Amendments to the Drawings:

The attached annotated drawing sheet and replacement drawing sheet make changes to Fig. 4 and replace the original sheets with Fig. 4.

REMARKS

Annotated Fig. 4
Replacement Fig. 4

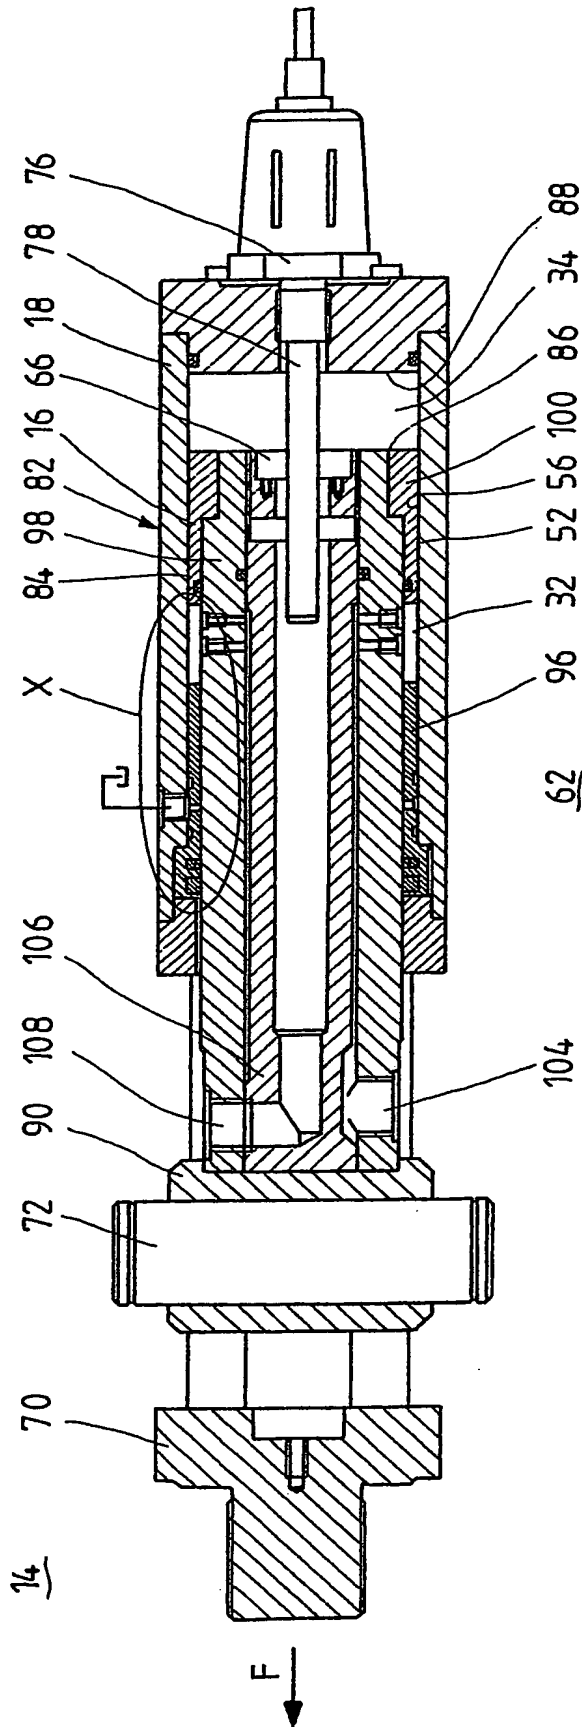
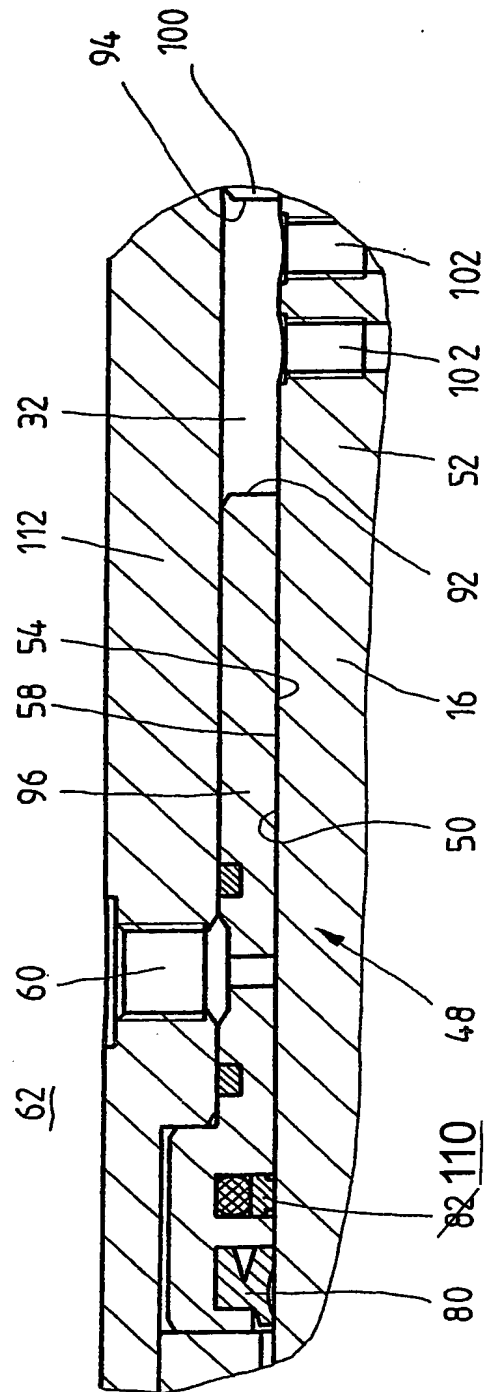
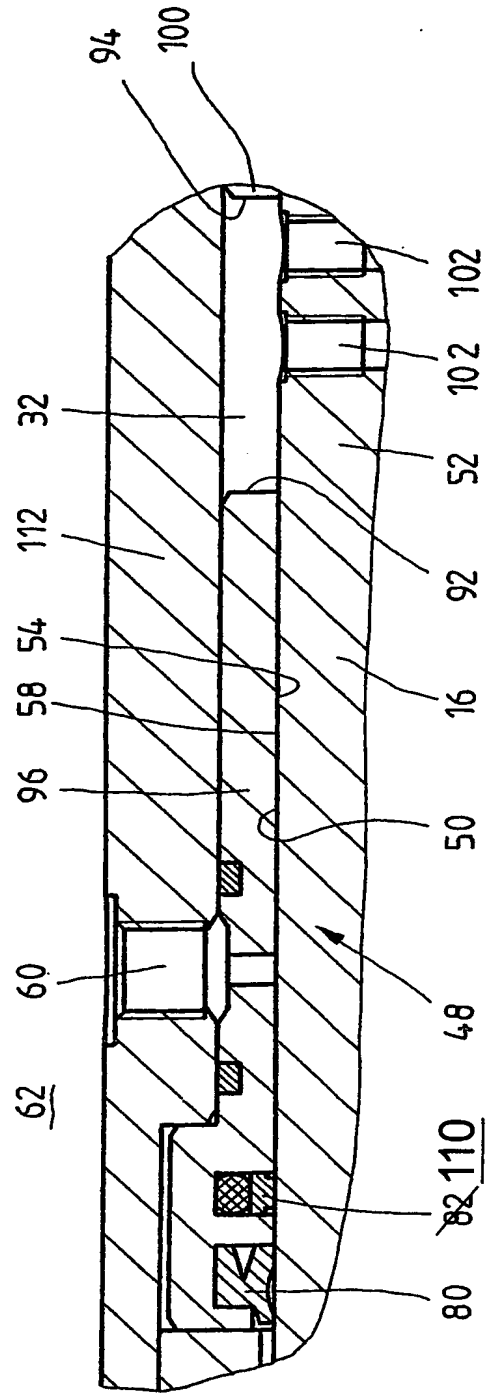
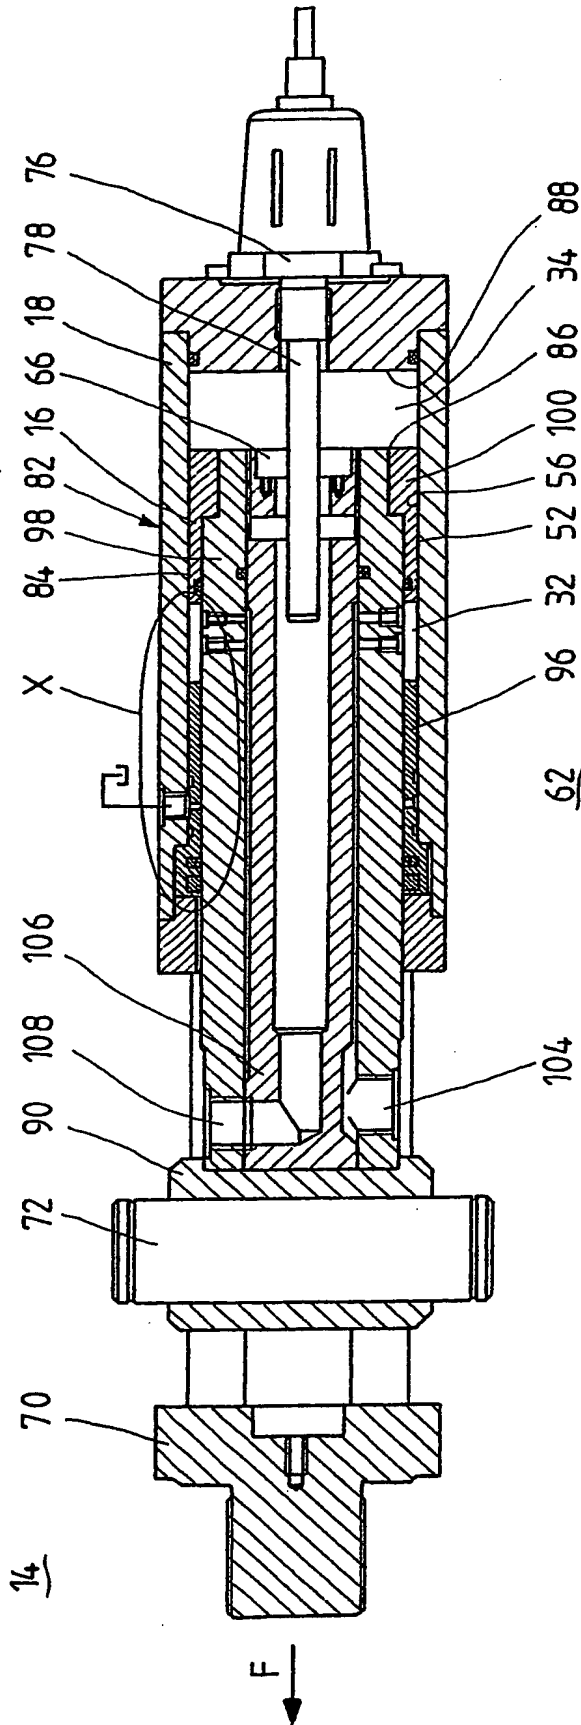
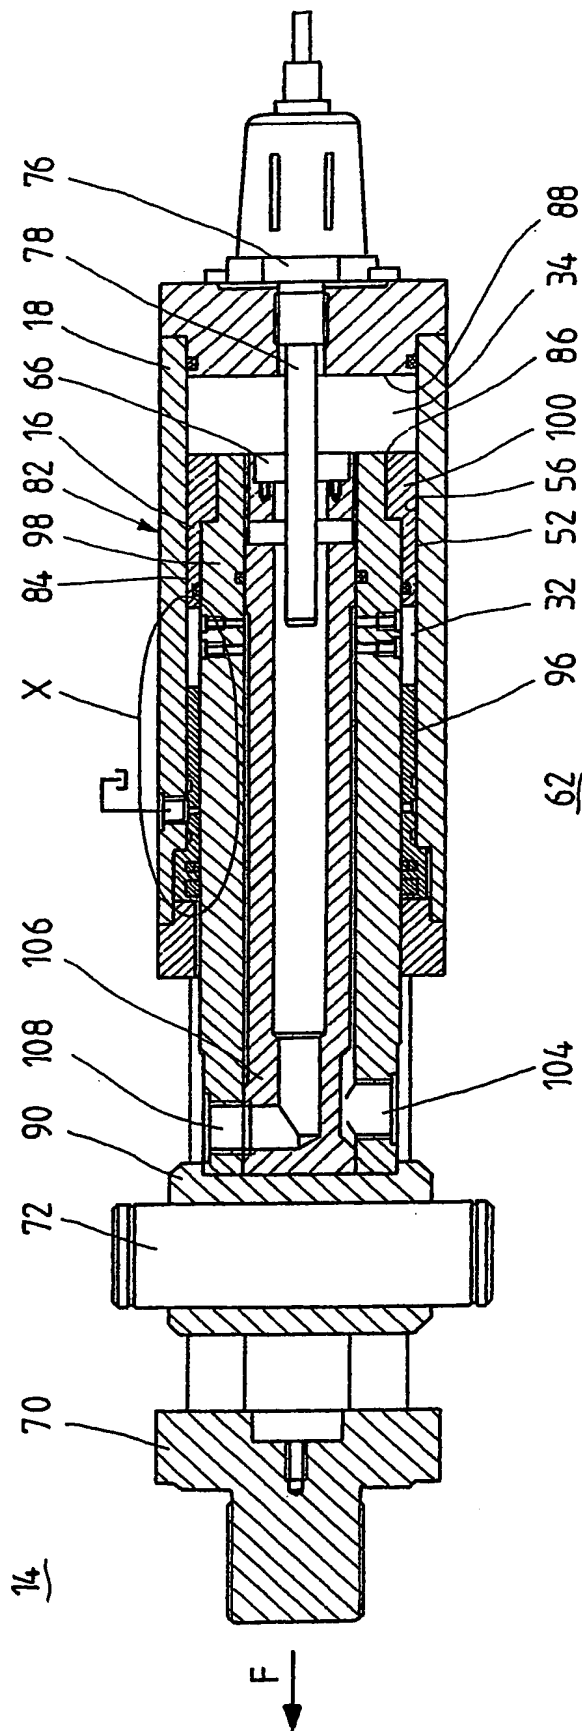
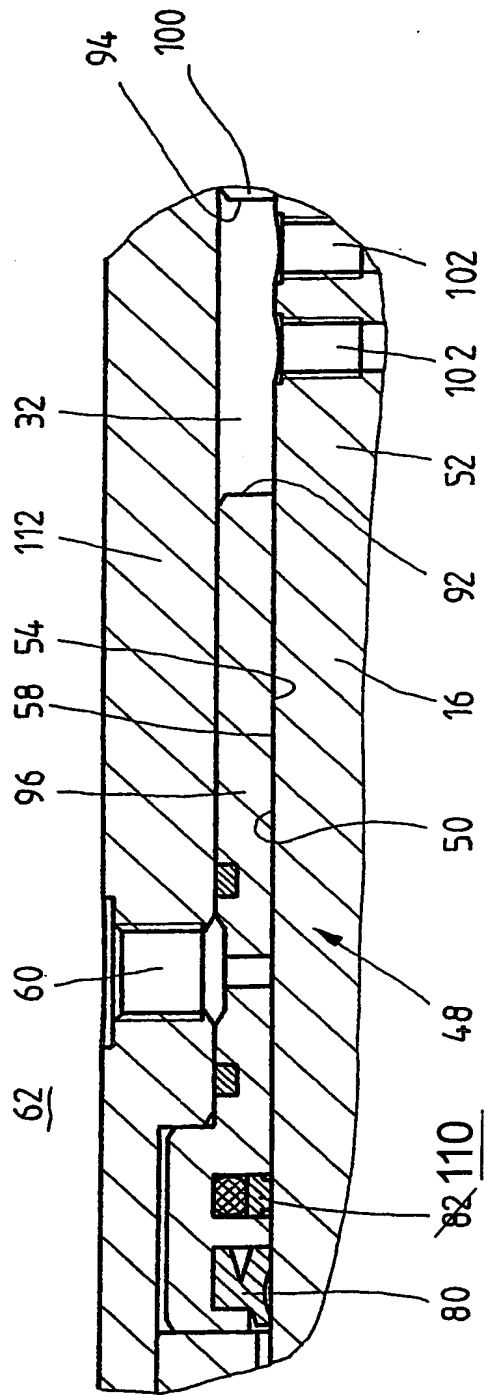
The amendments to the drawings filed on February 8, 2008 were objected to for failing to include annotated drawings. Annotated drawings and replacement drawings are included with this Amendment. Therefore, it is respectfully requested that the objection be withdrawn.
